PROJECT NAME: EDGEWATER RESIDENCE
 LOCATION: 2803 EDGEWATER DRIVE, AUSTIN, TX 78738
 ZONING: LA
 LEGAL DESCRIPTION: LOT 8, BLOCK 1, AUSTIN LAKE ESTATES, SECTION TWO, A SUBDIVISION IN TRAVIS COUNTY, TEXAS, ACCORDING TO THE MAP OR PLAT THEREOF RECORDED IN BOOK 9, PAGE 82, TRAVIS COUNTY PLAT RECORDS.

EDGEWATER VARIANCE
191023

2803 EDGEWATER VARIANCE REVISION NOTES : Highlighted Points

SITE PLAN @ STREET LEVEL

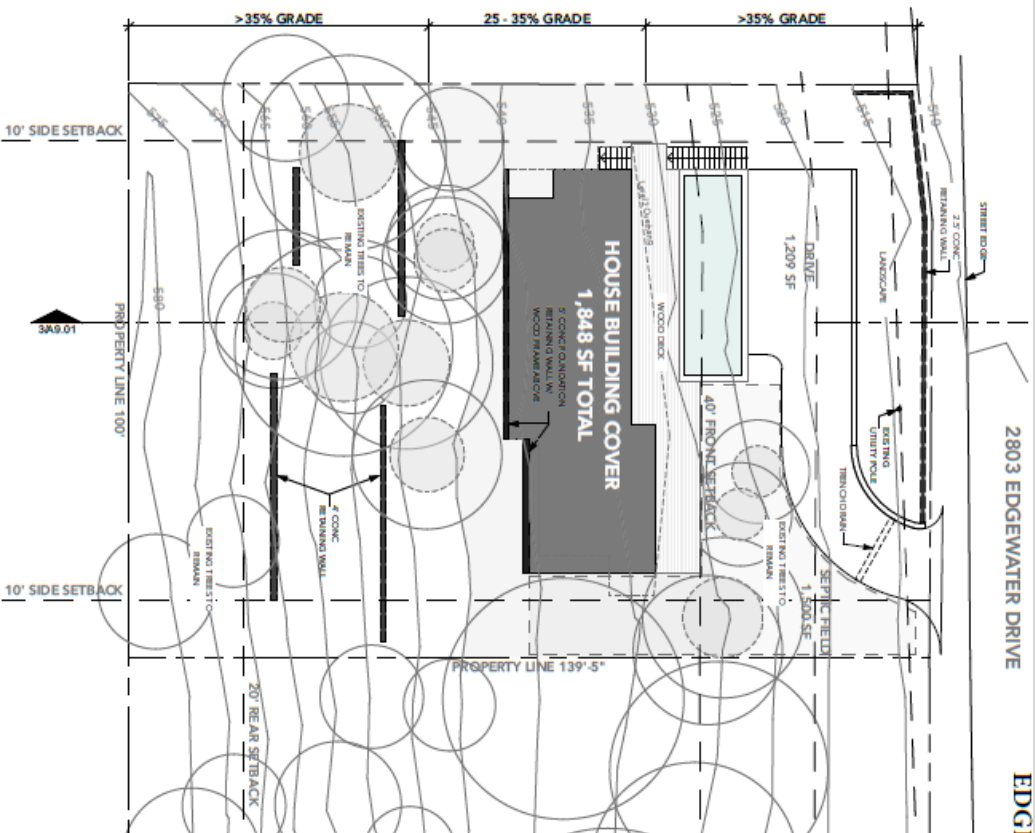
PREVIOUS	REVISED
1ST LEVEL	1,588	1,556
2ND LEVEL	1,506	1,458
BALCONY	144	147
GARAGE	480	0
TOTAL BUILDING AREA	3,718	3,161
BUILDING COVER	2,233	1,848
DRIVEWAY	1,513	1,209
UNCOVERED DECK	569	429
OTHER	387	469
TOTAL IMPERVIOUS COV. 5,469	3,955	3,955
LOT SIZE	13,935	13,935
TOTAL IMPER. COV. %	39%	28%

REVISED IMPERVIOUS COVER TABULATIONS BOA HEARING 11/07/19

SLOPE GRADE	SF PER ZONE	ALLOWABLE % PER ZONE	PROPOSED % PER ZONE	ALLOWABLE SF PER ZONE	PROPOSED SF PER ZONE
0-15%	-	35%	-	-	-
15-25%	3,892 SF	10%	59%	196 SF	2,279 SF
25-35%	10,043 SF	0%	17%	0 SF	1,676 SF
OVER 35%	-	-	-	-	-
TOTAL	14,935 SF	0%	17%	196 SF	3,811 SF
